**From:** [Rebecca Phillips](#)  
**To:** [Jenah Thornborrow](#)  
**Cc:** [Hanna Veal](#); [Mary Ann Waldinger](#); [Kristy Inselman](#)  
**Subject:** RE: Local Road implications  
**Date:** Friday, January 12, 2024 9:38:07 AM  
**Attachments:** [image007.png](#)  
[image008.png](#)  
[image011.png](#)  
[image012.png](#)  
[image013.png](#)  
[image014.png](#)

**Subject:** Local Road implications

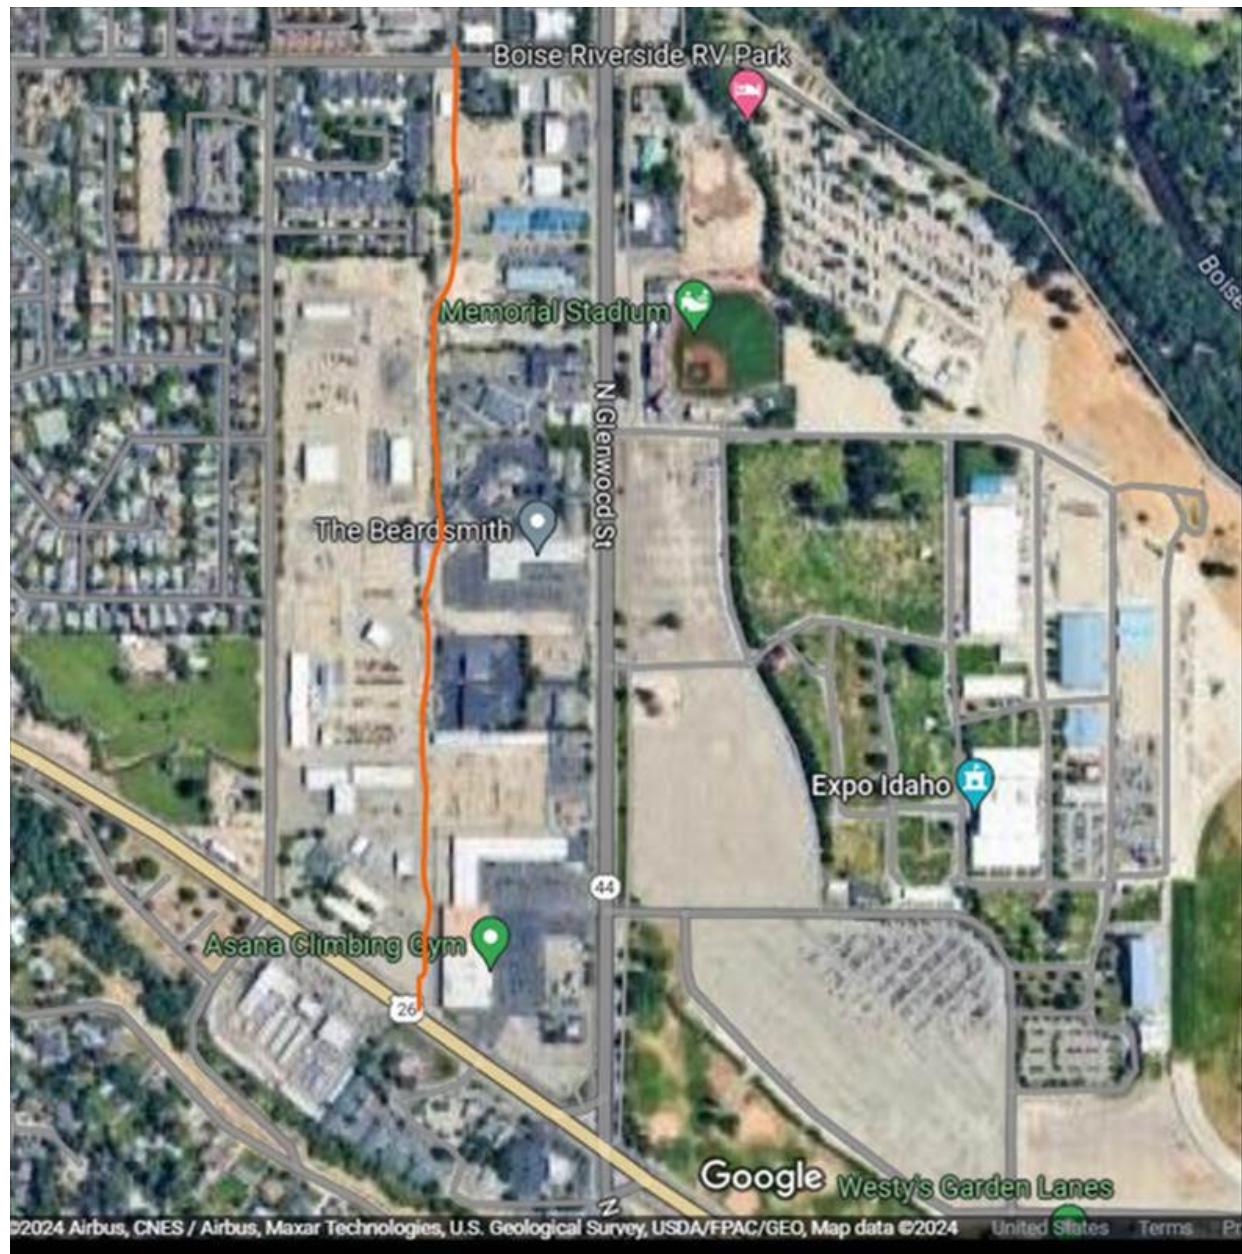
Also, given the challenges of full access at Chinden, we will assume a right in/right out for the new

I drive this frequently and I think the concrete “curb like” barrier starts at Dresden. Plus, this section is dicey with folks taking left in and left outs...

Good afternoon. Garden City has a planning document that suggests a new local road running parallel and between Coffey Street and Glenwood from Chinden to Marigold, very crudely drawn below. The City gets a lot of complaints about Coffey being a cut-through. We have two developments in at the city that are proposing not putting this road in. We do not have enough information to know what this would do to traffic flows. Would it be possible to potentially ask you to provide us with technical support?

Would a road that connects at arterial and collector be allowed to be the 27' wide street section?

Regarding your question about the roadway width on the new local road design. ACHD recommends that this roadway be constructed as a 36-foot wide commercial street section with vertical curb, gutter, and 5-foot wide concrete sidewalk on both sides of the roadway.
